STAFF RECOMMENDATION

NCPC File No. 6666

**LAFAYETTE BUILDING
BUILDING MODERNIZATION
811 Vermont Avenue, NW
Washington, D.C.**

March 29, 2007

Proposed Layout of Retail and Second Building Lobby Entrance

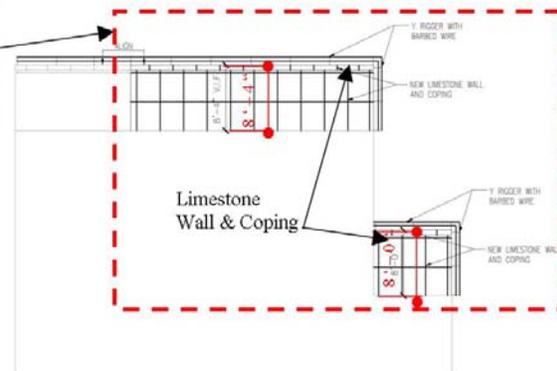
The building includes 8,919 usable square feet (USF) of ground floor retail along 15th Street. GSA has selected the baseline design to retain and restore existing retail space for continued retail use. This would add a secondary building entrance on 15th Street and a separate access corridor for retail tenants, reducing the retail space to 5,335 USF. GSA would restore the building's historic facade by replacing the double doors to the deli with limestone facing and carving a new lobby door with sidelights and transom to fill the storefront height. Although loss of the retail in its entirety (proposed previously) would have affected significantly the existing character of the building and the vitality of the adjacent streetscape, staff is satisfied with the current proposal to retain the majority of the retail space for its original purpose in the context of the restored facade.

Separation Fence-Wall Adjacent to Hotel Roof

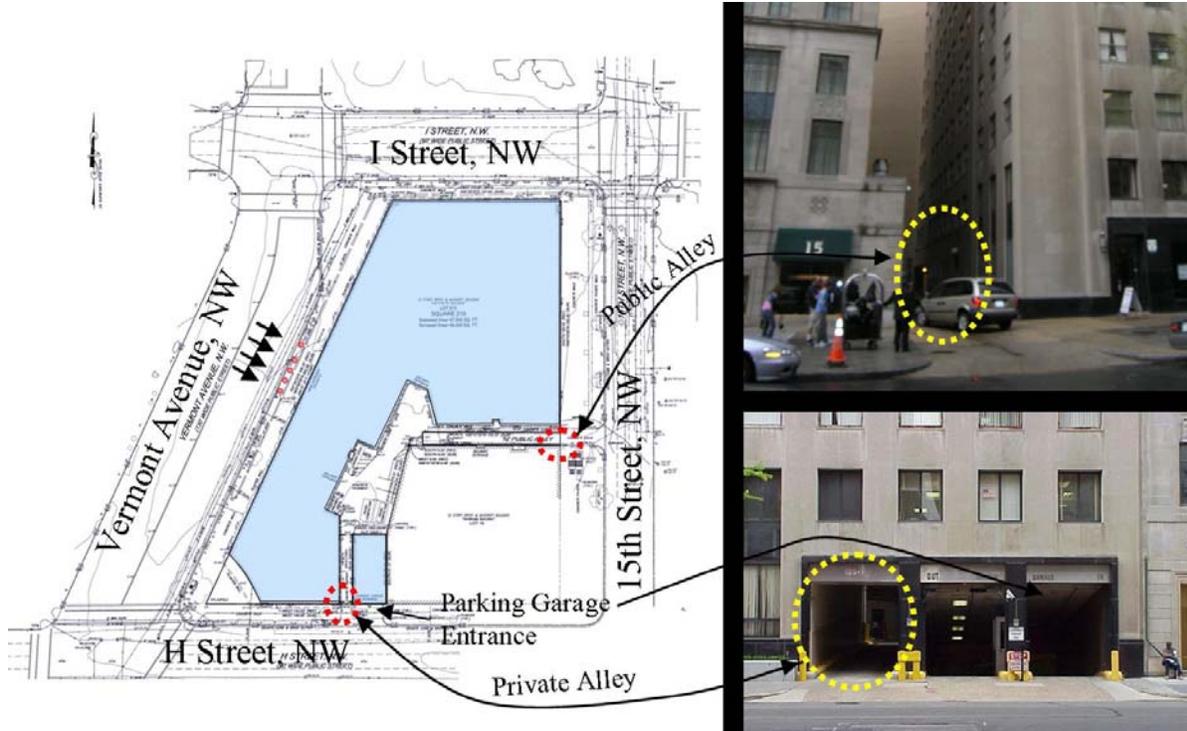
Staff recommends excepting from approval the fence-wall at the roofline between the Lafayette Building and the adjacent Shoreham Building. Roof plan drawings show a separation extending only at the penthouse level, but elevations show a stepped down wall 8-feet-4-inches faced with limestone at the penthouse and eleventh floor. However, the applicant’s architect provided a different drawing showing an earlier version, Option 2, of an 8-foot high black chain link no-climb fence with razor wire at the top. Pending clarification of which option is included and resubmitting, staff recommends that the Commission except this element from approval.

Guard Booth Option 2A

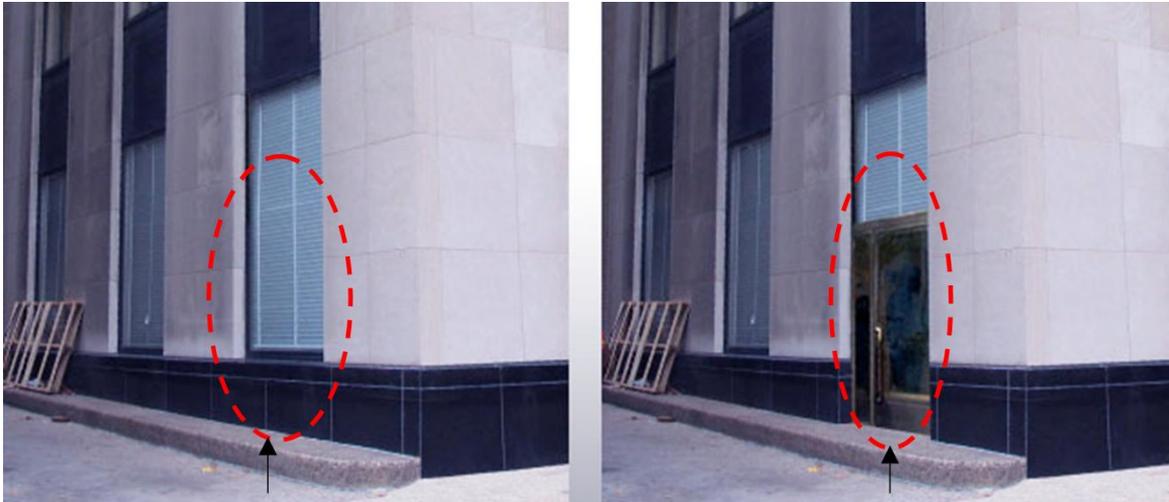
The applicant presented four options for a booth to guard the public alley off 15th Street between the Lafayette Building and the adjacent Shoreham Building hotel; three integral and one physically separated from the building. Of the options presented, staff prefers integral Option 2A for its minimization of effect on the building. However since none of the options are included in the Final Building Plans, staff cannot recommend approval of any of them. Although staff commends GSA for developing design strategies for perimeter security at the public alley from 15th Street, GSA has not yet consulted with DDOT, as recommended, to minimize encroachment of public space and minimize its adverse effect on the historic L’Enfant streetscape.
